# UNITED STATES PATENT AND TRADEMARK OFFICE

APPLICATION NO.	FILING DATE	FIRST NAMED INVENTOR	ATTORNEY DOCKET NO.	CONFIRMATION NO.
10/790,321	03/01/2004	John A Triunfo JR.	02-64	9016

**Office Action Summary**

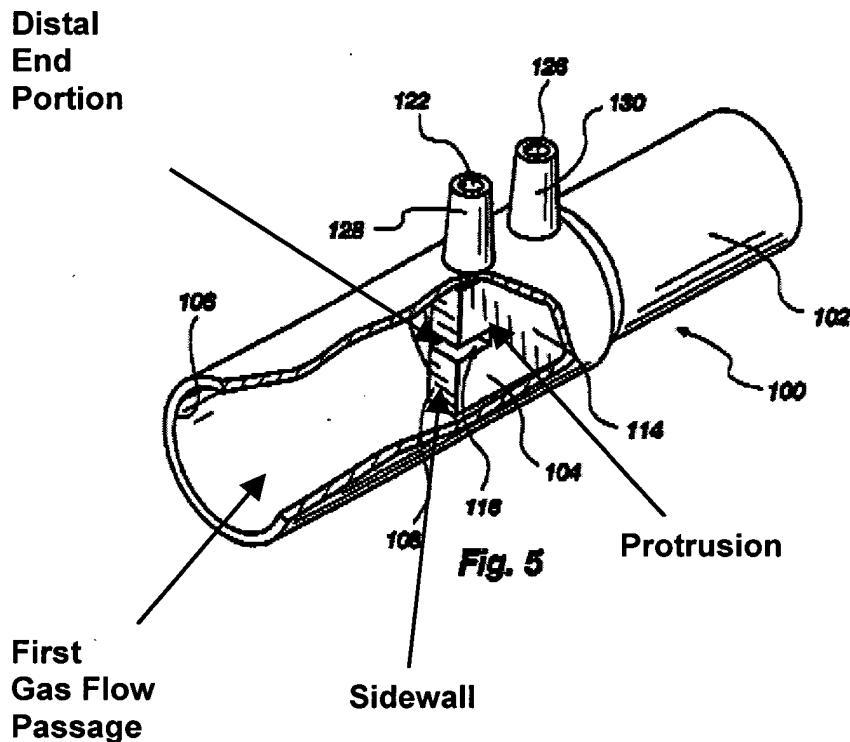
**Claims 1, 2, 4, and 6-13 are rejected under 35 U.S.C. 102(b) as being anticipated by Kofoed et.al. (5,379,560).**

Kofoed in an airway adaptor discloses:

- a tubular body (100) having a first gas flow passage defined therein (see illustration of Fig. 5 below); and

- a protrusion (see illustration of Fig. 5 below) extending from an interior wall of the tubular body into the gas flow passage, wherein the protrusion includes:
  - a distal end portion spaced apart from the interior wall of the tubular body (see illustration of Fig. 5 below) and
  - a second gas flow passage defined through the protrusion (116, 118, 216, 218) having an inlet at the distal end portion and an outlet at an exterior portion of the tubular body; and
  - a pair of side walls (see illustration of Fig. 5 below) disposed on the distal end portion of the protrusion such that each sidewall is generally parallel to a direction of a flow of gas through the first passage with inlet of the second gas flow passage disposed between the pair of sidewalls.

With respect to claim 6, Kofoed discloses wherein the sidewall extend along a length of the distal end portion of the protrusion such that a channel is defined between the sidewalls with the inlet of the second gas flow passage located at a bottom of the channel (see illustration of Fig. 5 above).
